To: Auburn Planning Board
From: Megan McLaughlin, City Planner II & Audrey Knight, AICP, City Planner/Urban Development Coordinator
Re: 671 Washington Street North (PID 189-011), Proposed Construction of a 8,700 Square Foot Storage Unit Addition to Existing 3,200 Square Foot Storage Facility in the General Business Zoning District.
Date: August 13, 2019

Figure 2: Site Plan: 671 Washington Street North

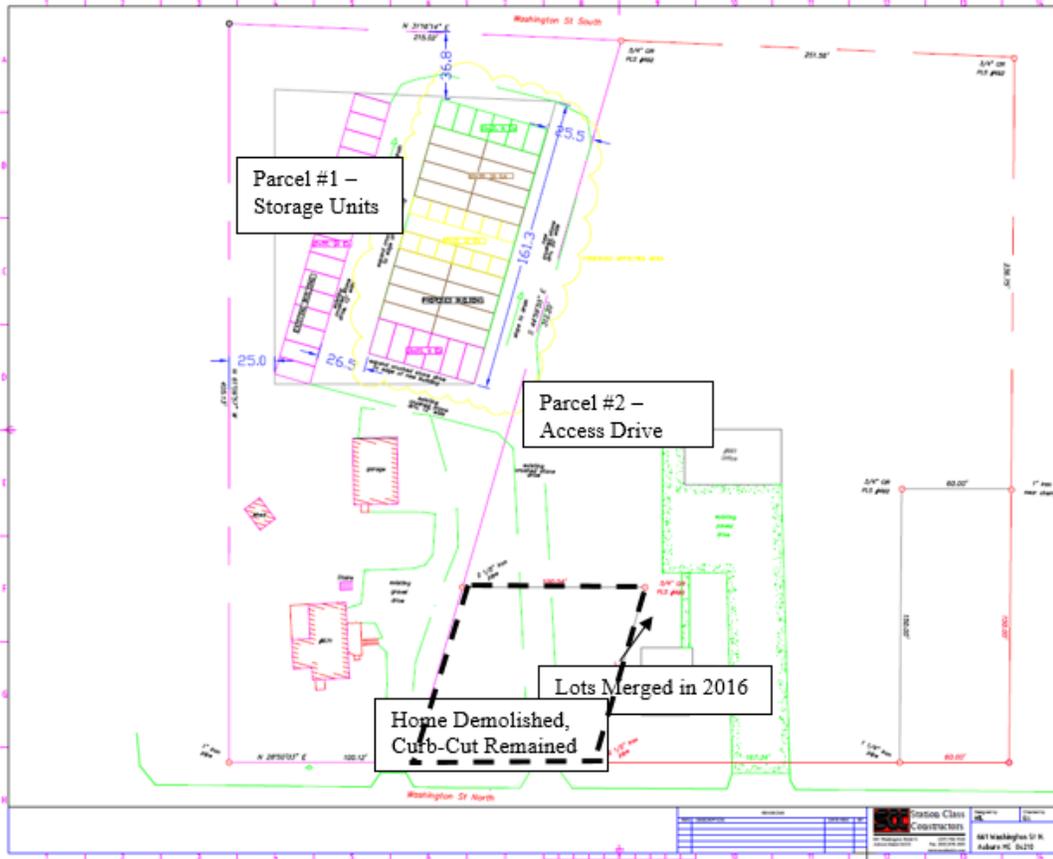
The Applicant prefers to keep the gravel drive to the single-family rental home as a separate and distinct access. The curb-cut for the crushed stone drive was serving a demolished single-family home that was originally on a separate lot (referred to as 665 Washington Street North – black dotted area in *Figure 2* below). In June of 2016, 665 Washington Street North was combined with 661 Washington Street North which is shown as the second parcel on the Site Plan. These actions typically require the access to be removed.

The City's Access Management Ordinance requires 230 feet between curb cuts on a 45MPH roadway (Sec.60-800). The applicant is currently using three curb-cuts to serve their mixed-use development in the General Business zone, with distances of approximately 65' between the two former residential drives, and approximately 90' from the paved combination office and residential use, for a combined distance of roughly 175'. The frontage of both properties is roughly 415', with the larger parcel occupying roughly 320' of frontage.

The Applicant would need to request a modification from Sec. 60-800(a) – Curb Cut and Driveway Spacing for either scenario, per Sec.60-806 (see attached ordinance language). For safety reasons, the Engineering Department does not recommend this modification be granted. The existing paved drive on Parcel #2 (*Figure 2*) could be extended to access the storage units and would only require a reduction of the standard by 50 feet.

When we met on site with the Applicant, we also discussed the use of reclaim instead of gravel for the area accessing all units to help with fugitive dust. The existing paved drive that serves their main office is approximately 30' in width, with a curb-cut opening of 36', a sufficient width to serve the expanded commercial use. The drive serving the residential rental is roughly 15' with a curb-cut opening on Washington of about 20'. The old residential drive being proposed to serve the storage unit complex is roughly 16' in width.

Planning Staff has a concern about the use of gravel for the driveway and recommends the Applicant use 3-4 inch reclaim with a 15 foot paved driveway apron.

- The access drive shall be comprised of 3-4 inch reclaim with a 15 foot paved driveway apron.
